April 13, 2015

**Subject: Century Tire Plaza – 195 Kennebec Street
Project ID# 2015-027
Review Comments Received April 8, 2015**

DESIGN: PBB
 DRAWN: DEPT.
 CHKD: PBB
 DATE: JAN 2015
 SCALE: 1"=20'
 CENTURY TIRE SITE RENOVATION
 MARGINAL WAY, PORTLAND, MAINE
 LANDSCAPE PLAN
 PROJ. NO. -
 DWG. NO. L1.1
 REV. C

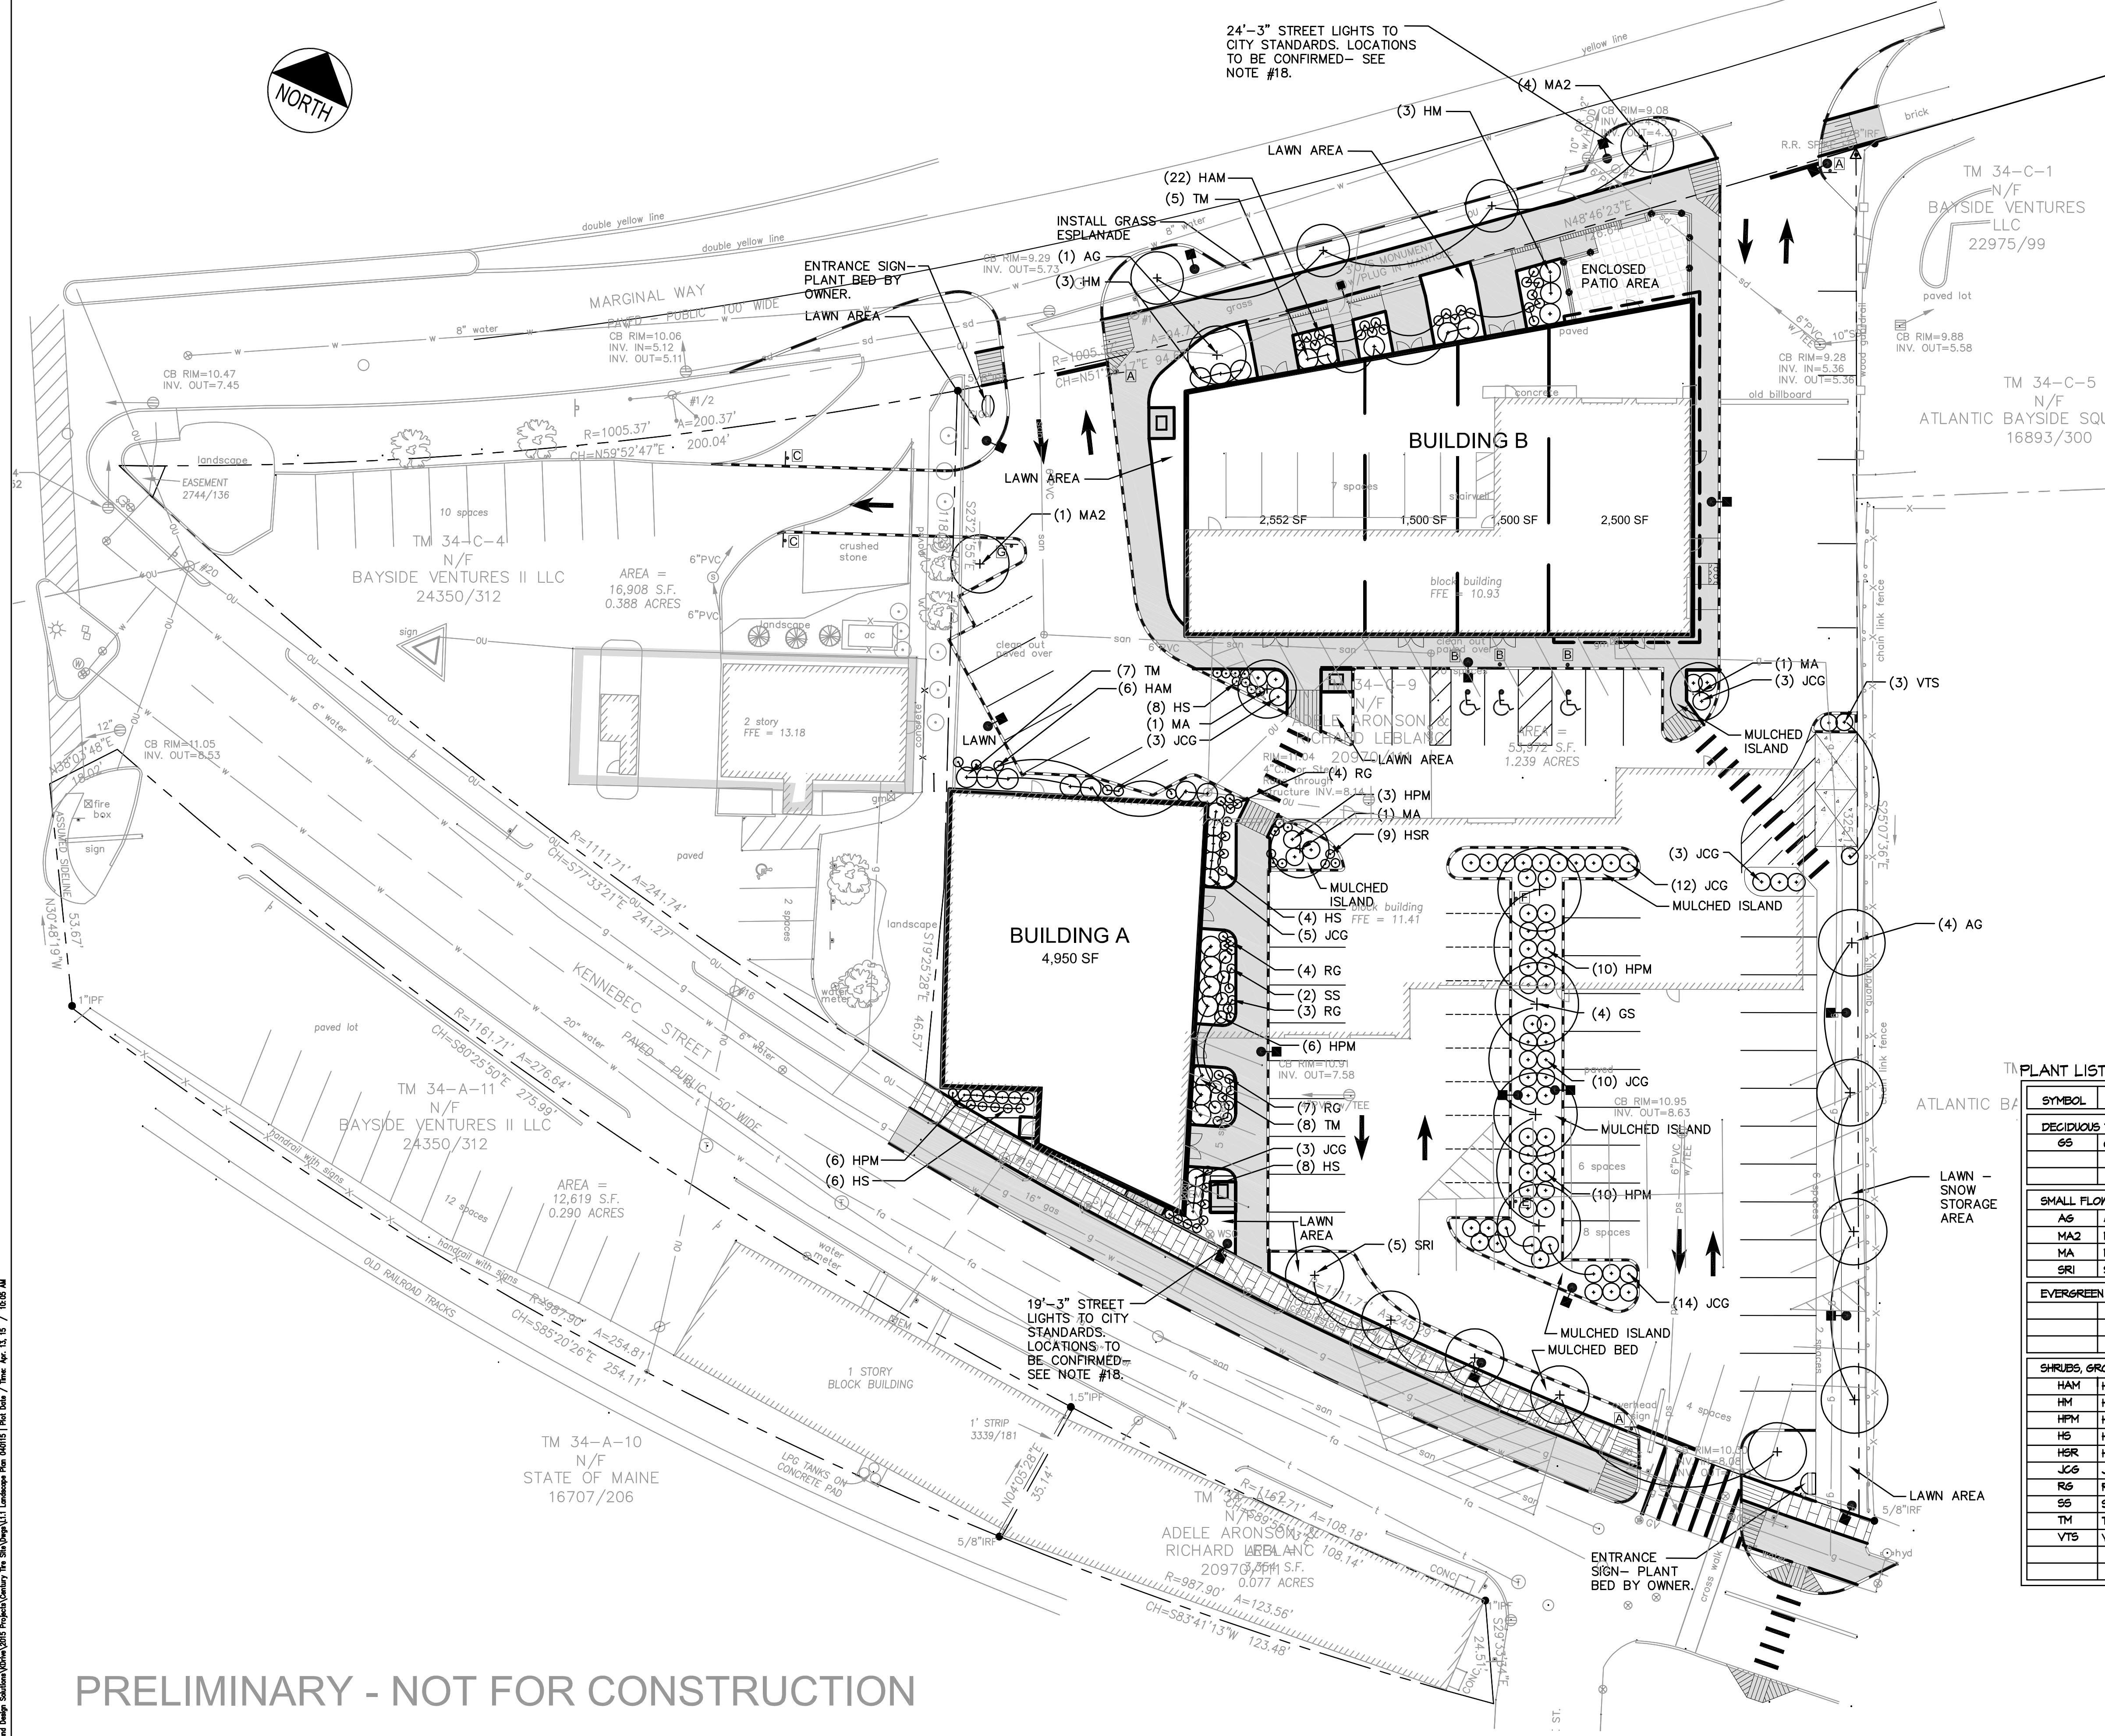
Likewise, per our development review meeting this morning, DPS has advised that note #18 on the landscape plan should be struck. DPS has also asked for an electrical plan for the streetlights. Apparently there are some considerations about tying in with the network east of here.

There are some concerns about continuing to plan to store snow along the pedestrian pathway along the eastern edge of the site. How will this work with curbing? It seems like all snow may need to be removed?

Note 18 has been removed from the revised Landscape Plan. An electrical plan for the street lighting will be provided under separate cover.

The snow storage area will be eliminated at the eastern edge of the site. Snow will be eliminated at the eastern edge of the site. Snow will need to be removed.

BRICK SIDEWALK WITH BITUMINOUS BASE

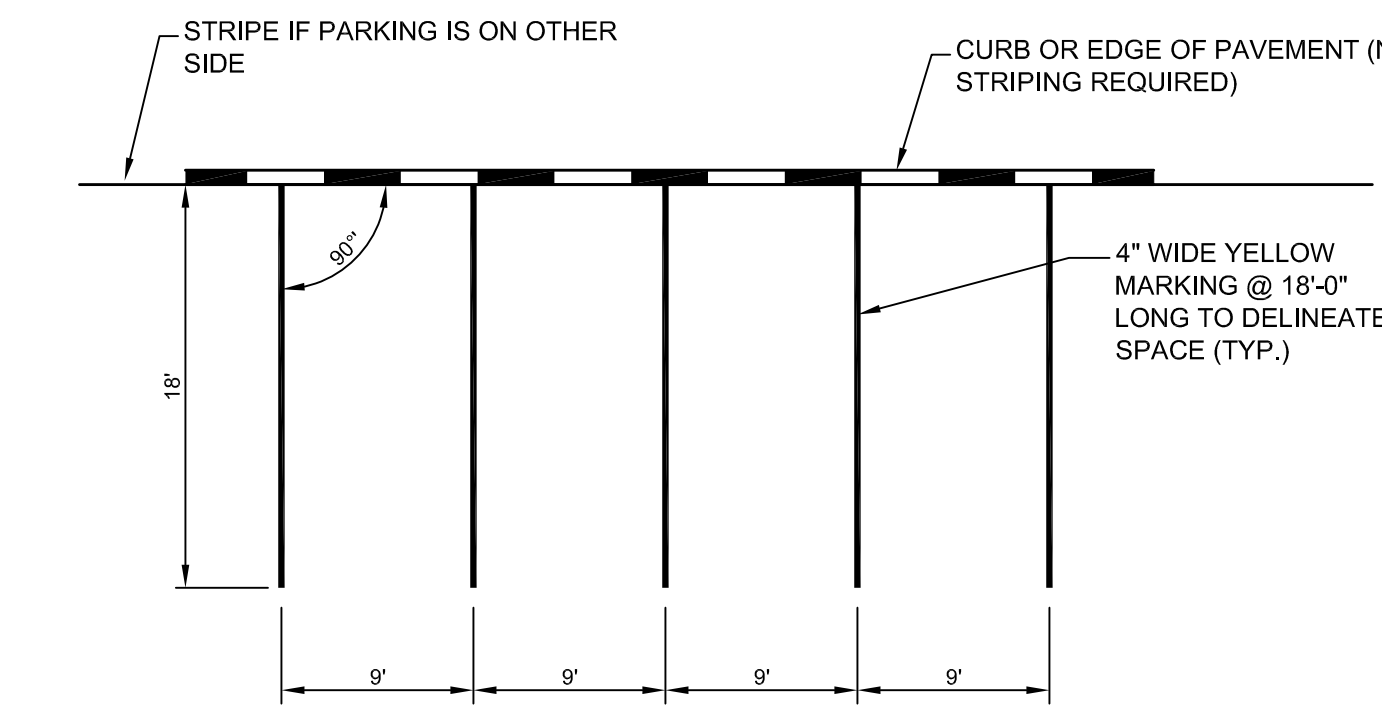
Detail C on plan sheet C-7.0, detail D on sheet C-7.2, and detail E on sheet C-7.2 all should be corrected to show the City standard for depth of base gravel for a brick sidewalk on bituminous base. The depth of gravel should be 10 inches, not 4 inches as indicated in the above referenced details.

The referenced details have been amended on the revised plan sheets to conform to City Standards.
